SKEP III Home Office Support Site Visit Report

Consultant	Wahib Medanat Consultant Engineer	Rep No.	13-09052022
Contractor	Derar Saraireh & Sons for Engineering & Contracting	Tender No.	(11/2019/USAID/SKEP/3/S) Schools for a Knowledge Economy Project (SKEP) - Phase (3) Package (1, 2)
Site Name	Khadija Bint Khwailed Basic Mixed School- Shouna Janoubia	Day/ Date	Mon. 09/05/2022
Duration of Project	450 Calendar Days	Total Project Budget	9,789,417.840 JD

(Figure: 17 & 18)

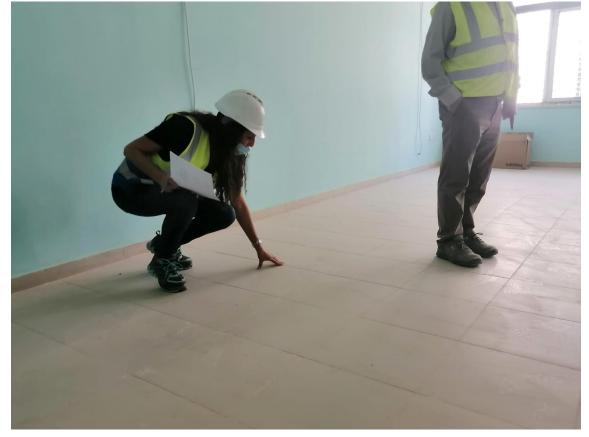
The team inspected the current status of the expansion joint at the corridor and approved the Contractor's method to complete the remaining work there with no objection to fix an extension to the metal part of the joint to cover the whole required length
